FDP - Amendment No. 1
Barefoot Lakes Filing No. 2
Planned Unit Development
COVER AND NARRATIVE
Town of Firestone
Weld County
State of Colorado
Sheet 1 of 36

BAREFOOT LAKES FILING NO. 2, AMENDMENT 1 - FINAL DEVELOPMENT PLAN

This document is an Amendment to Barefoot Lakes Filing No. 2 FDP, recorded on 2/15/2018 at Rec. #4375621 at the office of Weld County Clerk and Recorder.

The purpose of this First Amendment is to make adjustments that allow for a new community pool facility. Single Family lots have been reconfigured as part of this amendment in order to accommodate the land required for this new facility. After careful analysis of the overall Barefoot Lakes development, and the distribution of planned and existing amenities, this location has been selected for the new pool facility as it is centrally located to the parcels that are and will be located south of Ronald Reagan Blvd. Its location just off Barefoot Lakes Parkway makes it readily accessible to both the existing filings as well as to planned filings to the east.

FDP - Amendment No. 1
 Barefoot Lakes Filing No. 2
 Planned Unit Development
 TRACT & ADDRESS PLAN
 Town of Firestone
 Weld County
 State of Colorado
 Sheet 4 of 36

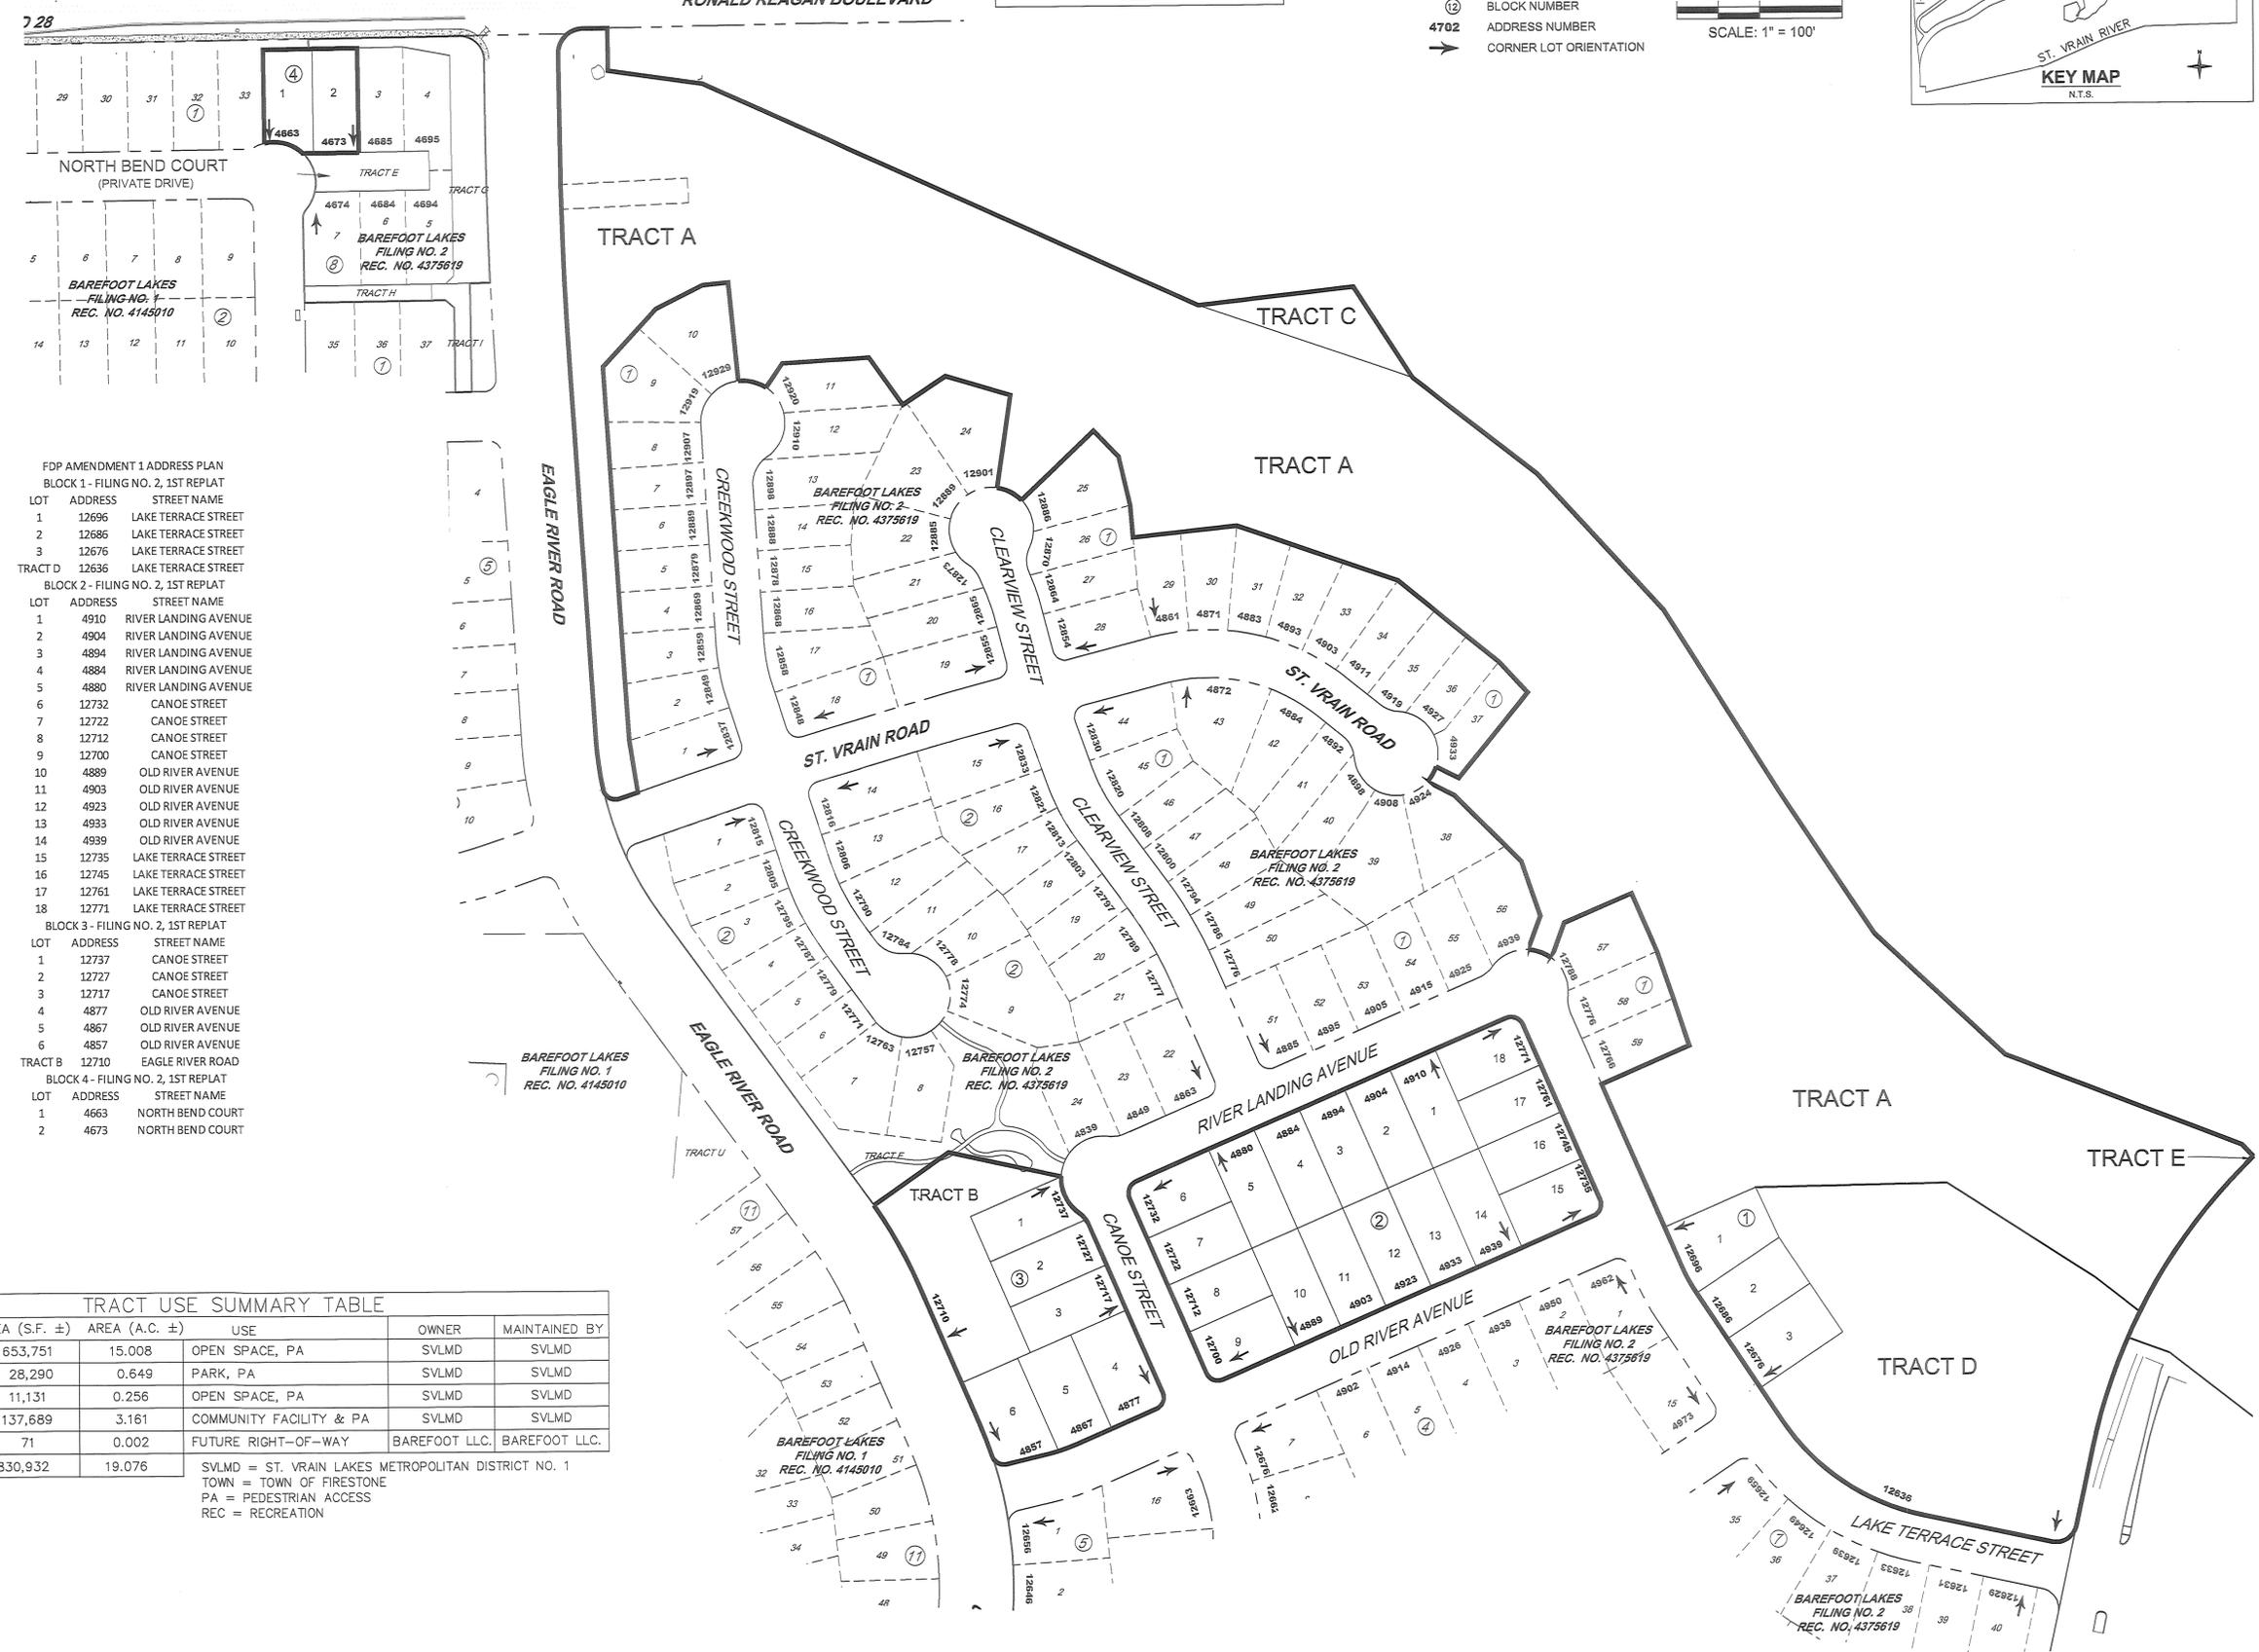
Other changes include a reconfigured Tract B to accommodate the relocated lots from the new pool facility location, but the park program and play equipment remain unchanged. 8 lots have been removed and three have been added in Block 1 next to the pool facility on Lake Terrace Street. Lots in Block 3 are being adjusted for size (being reduced from 67' width lots to 60' width lots) which allows the creation of two new lots. Two lots in Block 4 have minor lot line adjustments made to accommodate a side lot underdrain easement. The new pool facility is now located in Tract D. Signage, lighting, grading, planting and fencing have all been adjusted to accommodate the new facility, and remain in effect unless specifically modified by this Amendment.

1 POOL FENCE
 SCALE: 1/2" = 1'-0"

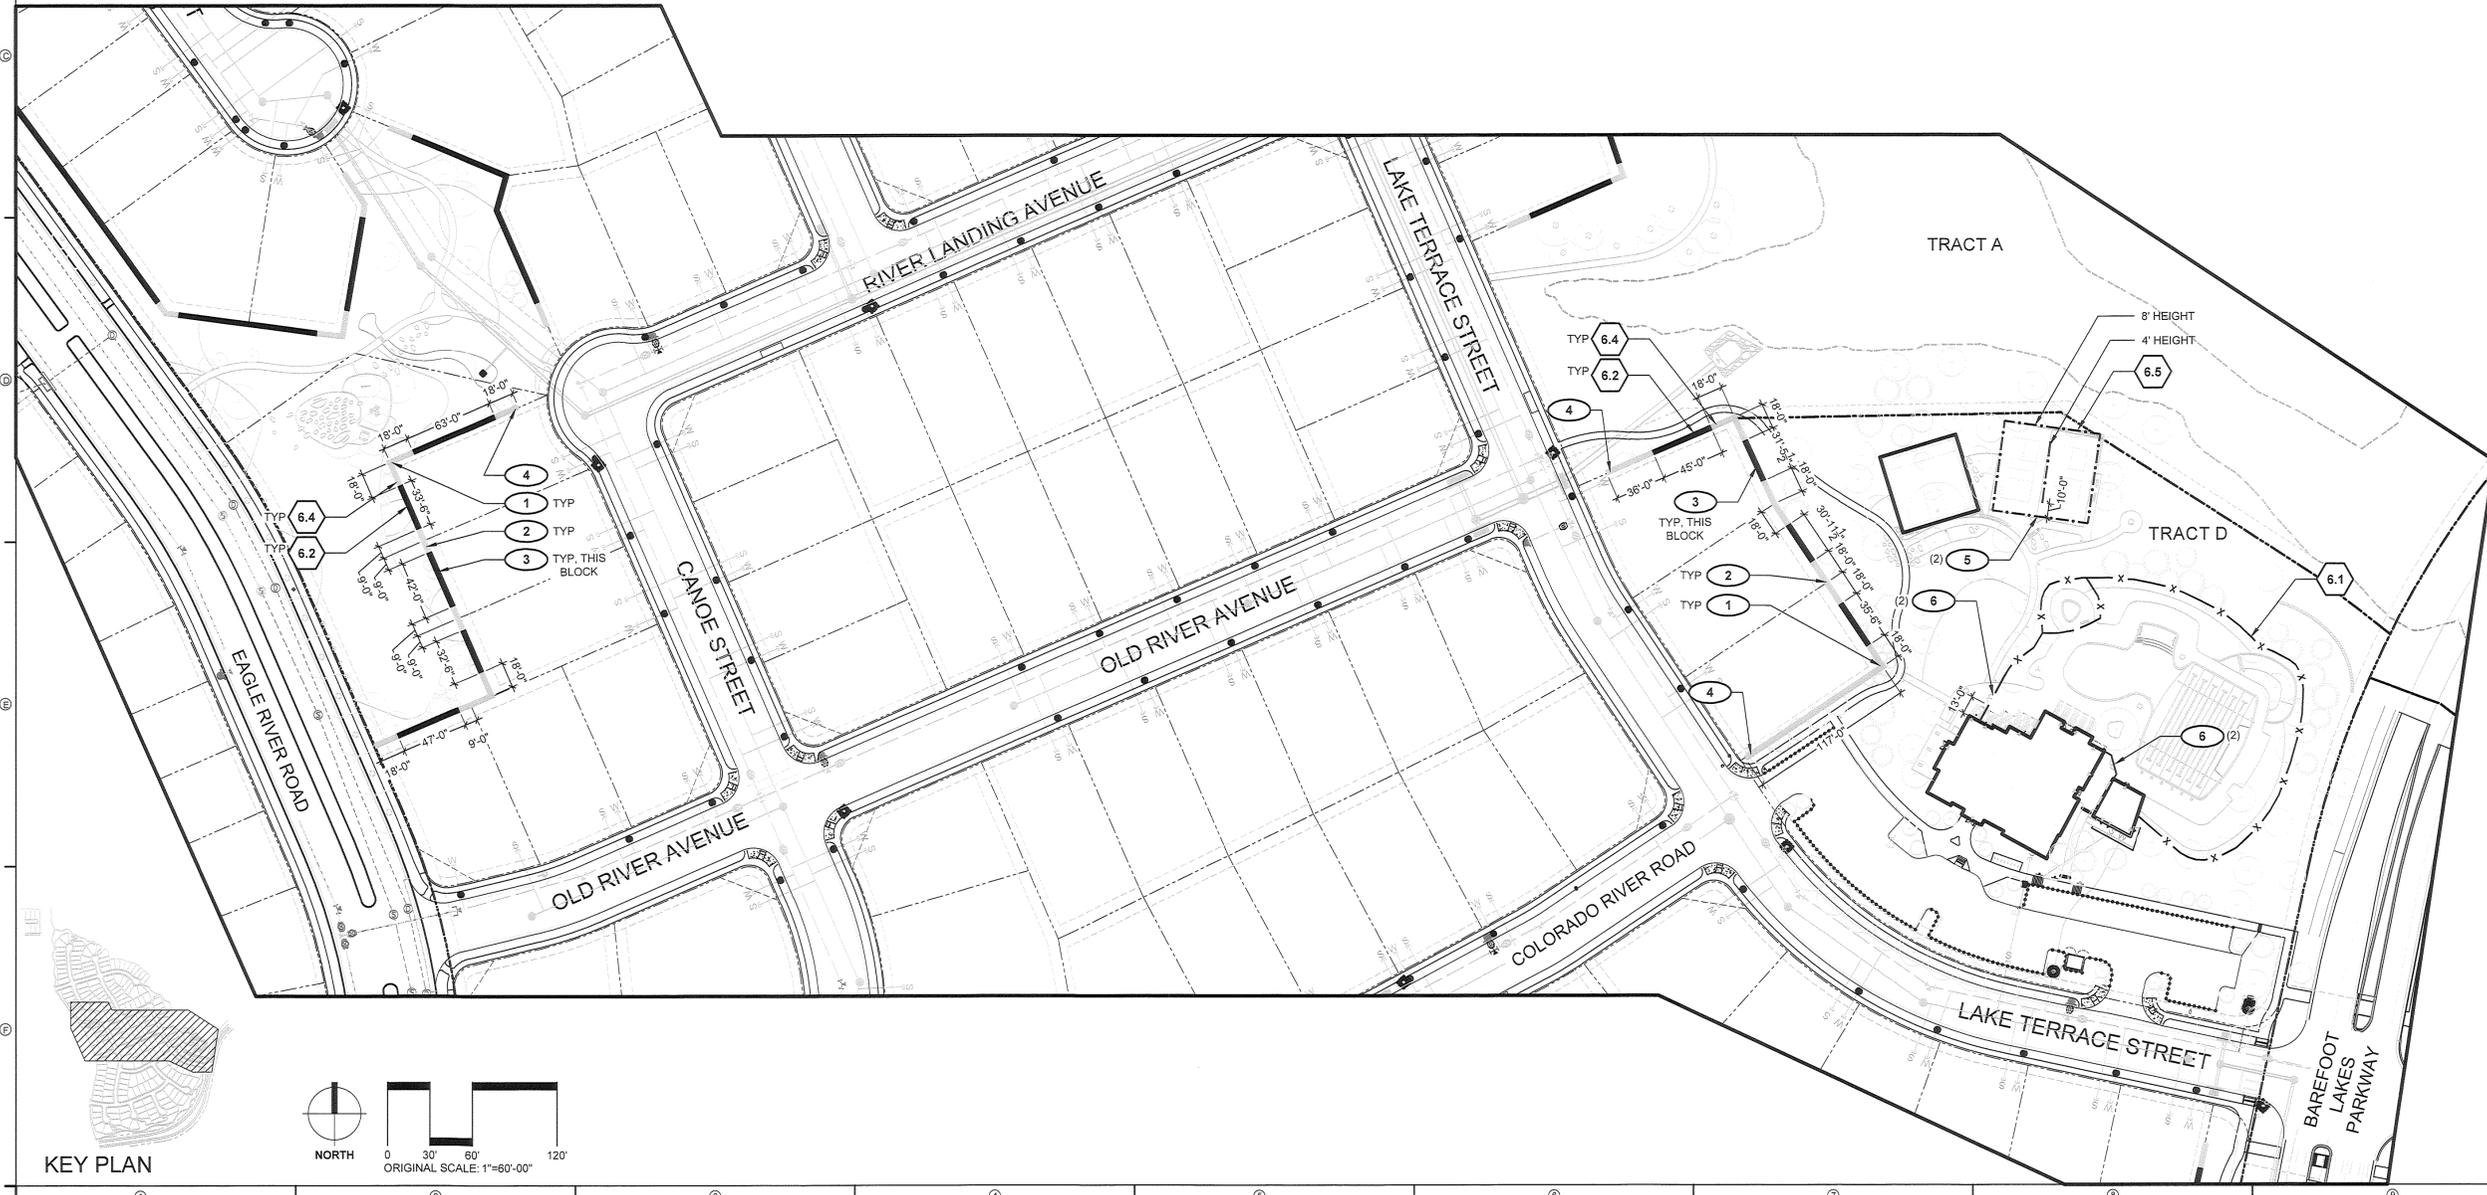
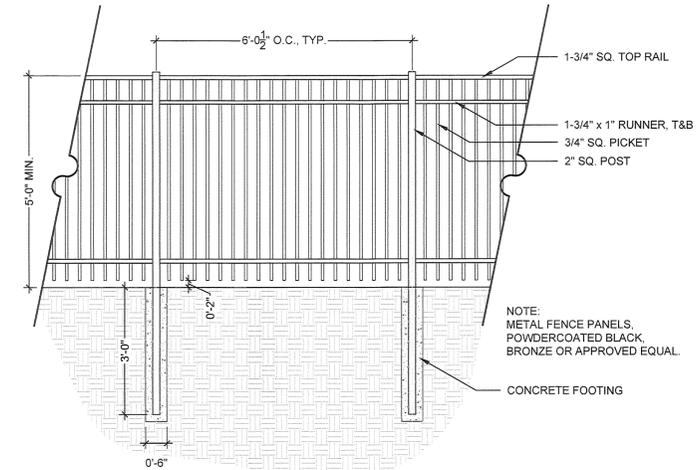
Fencing standards and details remain unchanged. The fencing plans are adjusted here for the changes to lot perimeters at the neighborhood park and adjacent to the new pool facility. A pool fence detail is added.

1. Refer to detail at right for [6.1] Pool Fence.
2. Pickleball fence is black chain link with windscreen.
 - 2.1. Refer to plan notes for fence height.
 - 2.2. Secure windscreen to perimeter fence per manufacturer's recommendations.
- 2.3. Windscreen product: 500 Series 80% MAXFlex PVC Mesh by FenceScreen® (or approved equal). Windscreen color: Forest Green.
3. Refer to associated details in the recorded Filing 2 FDP for the other fence types.

FDP - Amendment No. 1
 Barefoot Lakes Filing No. 2
 Planned Unit Development
 ARCHITECTURAL ELEVATIONS
 Town of Firestone
 Weld County
 State of Colorado
 Sheet 20 of 21

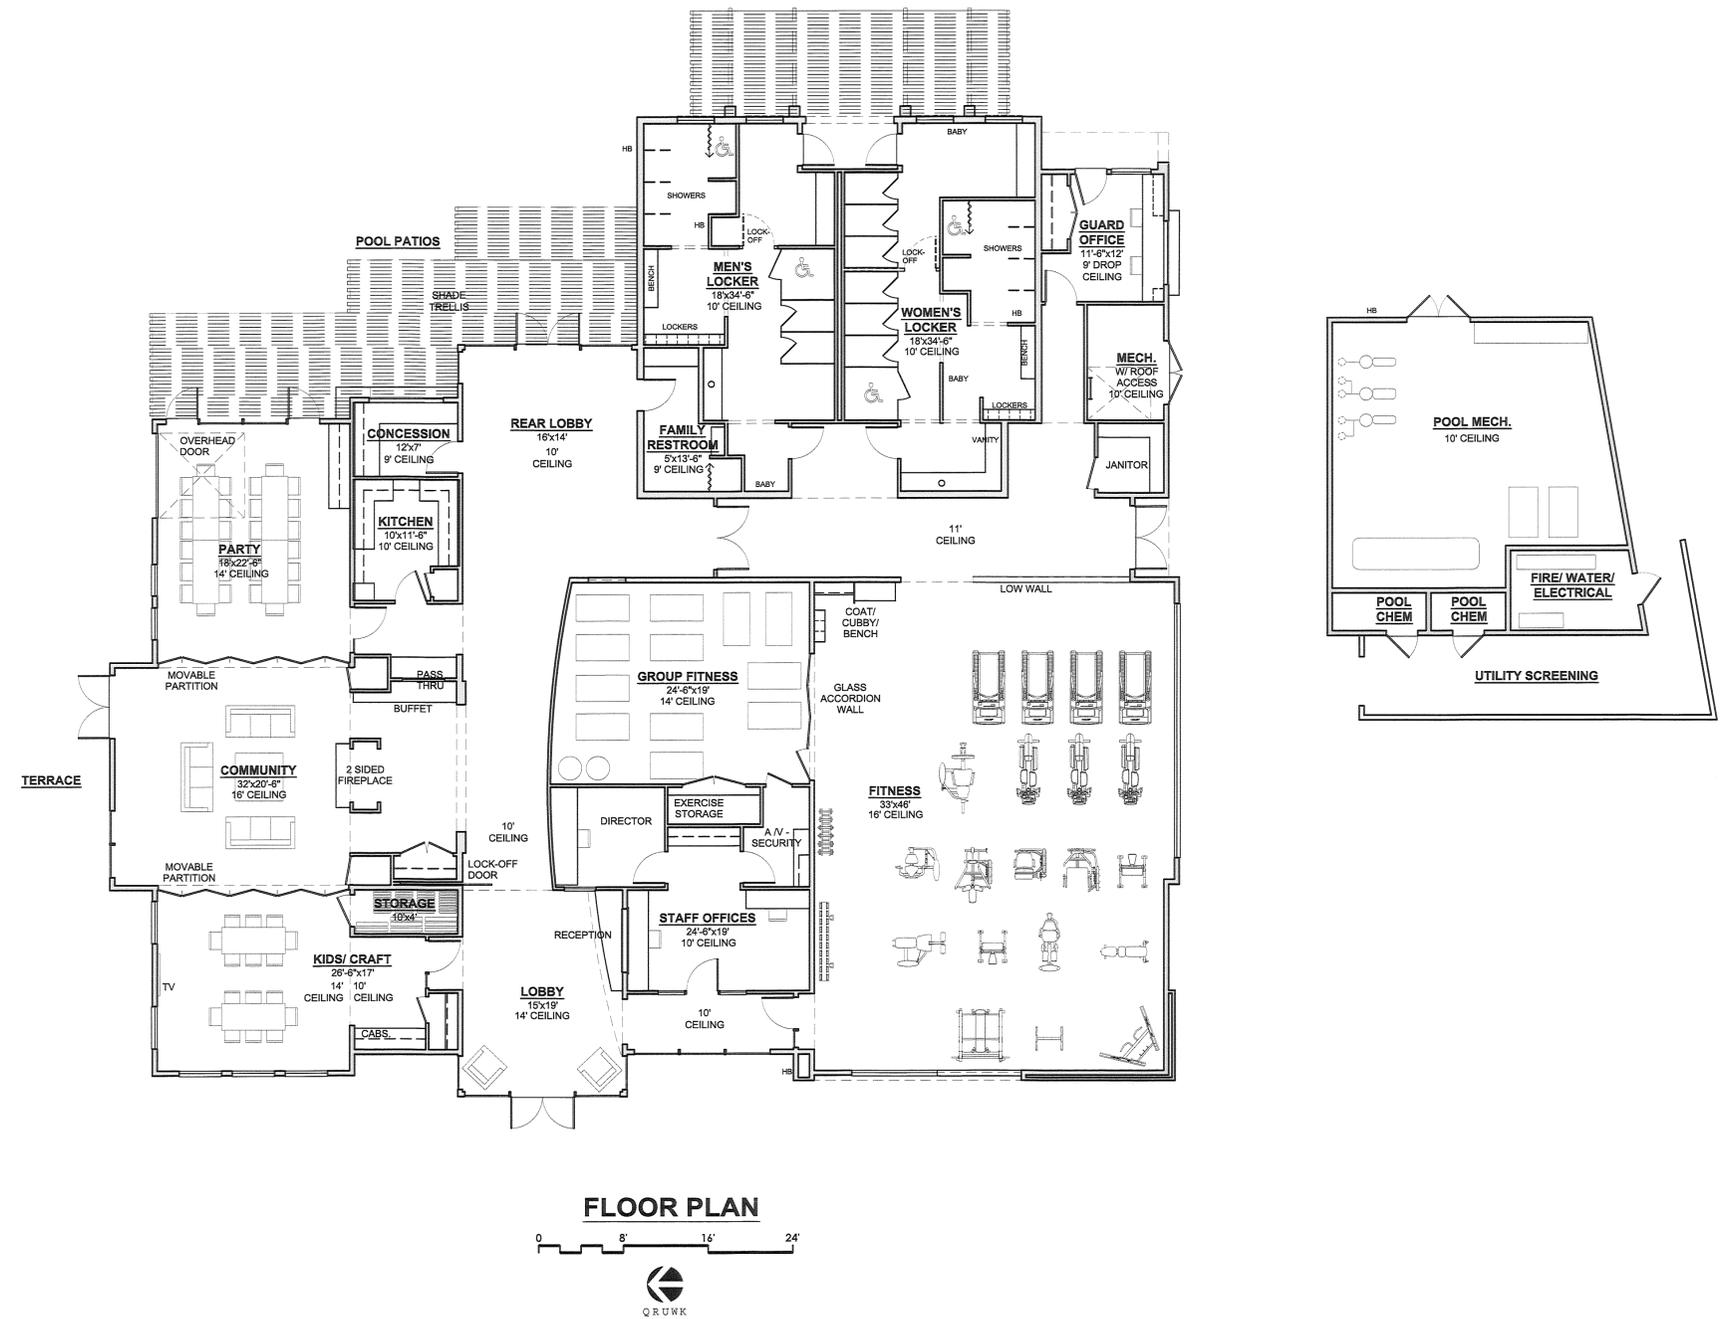
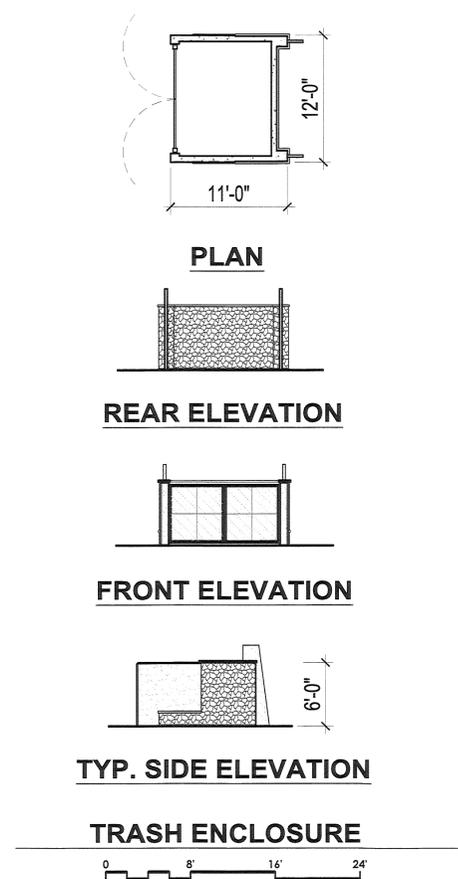
There are no revisions to the Architectural Design Standards. The Enhanced Elevation Table is revised for lots that have been added and removed. Because it is not a residence, the new pool facility is specifically designed, and the character elevations are included in this Amendment on sheets 19 and 20.
